Location/Address of Construction: 1039 RIVERSIDE ST BLDG #7		
Total Square Footage of Proposed Structure 25,000 SQFT + 5,000 CANOPY	Square Footage of Lot CONDO	
Tax Assessor's Chart, Block & Lot Chart# Block# Lot#	Owner: 1039 RIVERSIDE, LLC 55 HARDY RD FALMOUTH, ME 04105	Telephone: 797-6066
Lessee/Buyer's Name (if Applicable)	Applicant name, address & telephone: 1039 RIVERSIDE, LLC 55 HARDY RD FALMOUTH, ME 04105	cost Of Work: \$911,723 Fee: \$2226.50
<p>_____</p> <p>_____</p> <p>_____</p> <p>_____</p> <p>_____</p> <p style="text-align: right;">FOR</p>		
Contractor's name, address & telephone: HARDY POND CONSTRUCTION 1039 RIVERSIDE ST, SUITE 11 PORTLAND, ME 04103 Who should we contact when the permit is ready: BOB GAUDREAU 318-7512 CELL Mailing address: SAME AS ABOVE We will contact you by phone when the permit is ready. You must come in and pick up the permit and review the requirements before starting any work, with a Plan Reviewer. A stop work order will be issued and a \$100.00 fee if any work starts before the permit is picked up. PHONE: 318-7512

BUILDING #7 - 1039 RIVERSIDE DRIVE, PORTLAND, ME
BUILDING PRODUCTS
PRE-ENGINEERED BUILDING TO BE USED AS A STORAGE AND SALES FACILIT

Fire Resistance Ratings - ANSI/UL 263

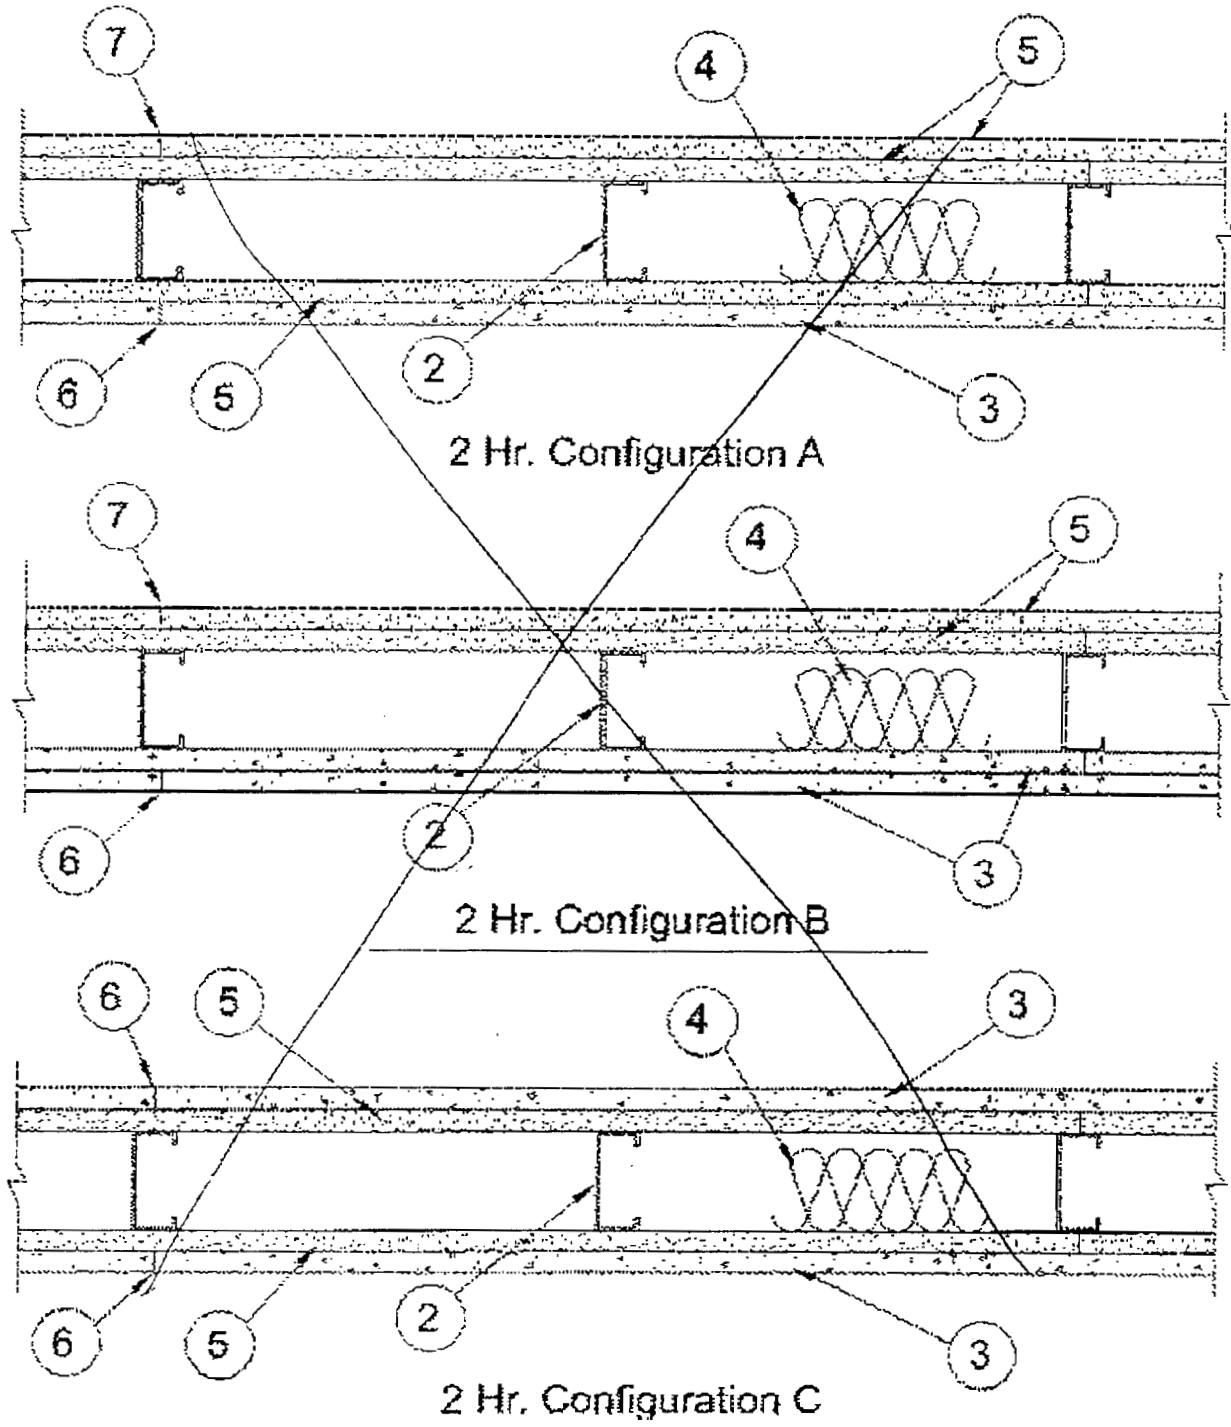
- 1) The "Kirby" plans are not stamped.
- 2) Need a cross section of the fire separation assembly w/ UL listing
- 3) Need a Fire glazing detail w/ ASTM testing standard.

Design No. U404
June 10, 2003
